Number	Description
1	Added Supplement to Special Provision 907-618-4; Amendment EBSx Download Required.

SUPPLEMENT TO SPECIAL PROVISION NO. 907-618-4

DATE: 05/19/2026

PROJECT: MP-2178-05(002) / 309966301 – Benton County

ADDITIONAL TRAFFIC CONTROL SIGNS REQUIRED:

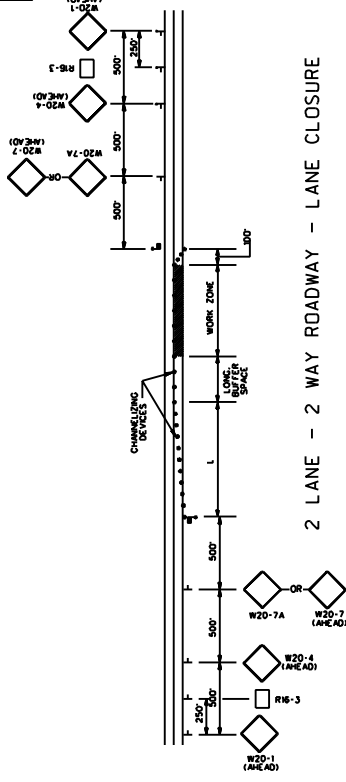
- 56 - W20-1 "AHEAD" signs required. One (1) W20-1 "AHEAD" sign is required at each local road or street entering the project.
- 144 - R4-1 "DO NOT PASS" signs required.
- 12 - R4-2 "PASS WITH CARE" signs required.
- 14 - W14-3 "NO PASSING ZONE" signs required.
- 20 - R16-3 "SPEEDING FINES DOUBLED" signs required.

R4-1 "DO NOT PASS", R4-2 "PASS WITH CARE", and W14-3 "NO PASSING ZONE" signs are required in accordance with Subsection 618.03.3, this drawing, and as specified in the Manual on Uniform Traffic Control Devices.

All construction signs and barricades shown on this page shall be included in the bid price for pay item 907-618-A, Maintenance of Traffic. Fluorescent orange sheeting shall be used on all construction and traffic control signs except for R16-3, R4-1 and R4-2 signs which shall be black legend and border on white background.

LOCATION OF R16-3 SIGNS

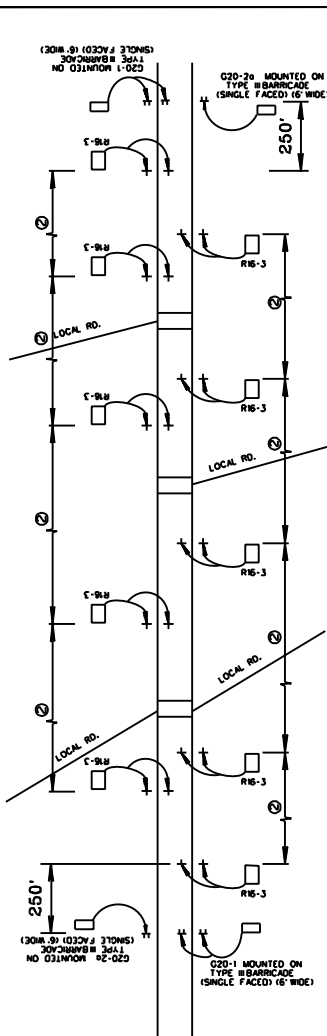
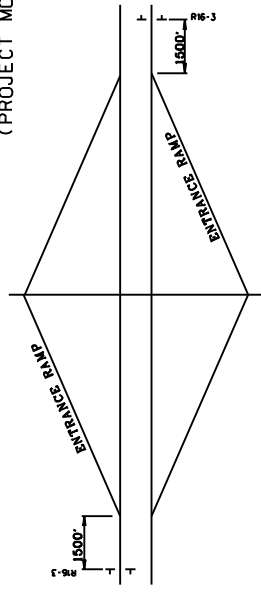
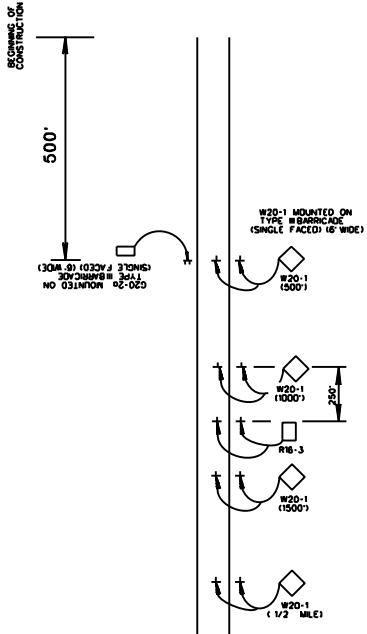
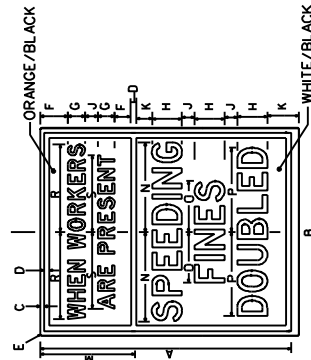
R16-3 signs shall be spaced in accordance with sheet titled "Location of R16-3 Signs".
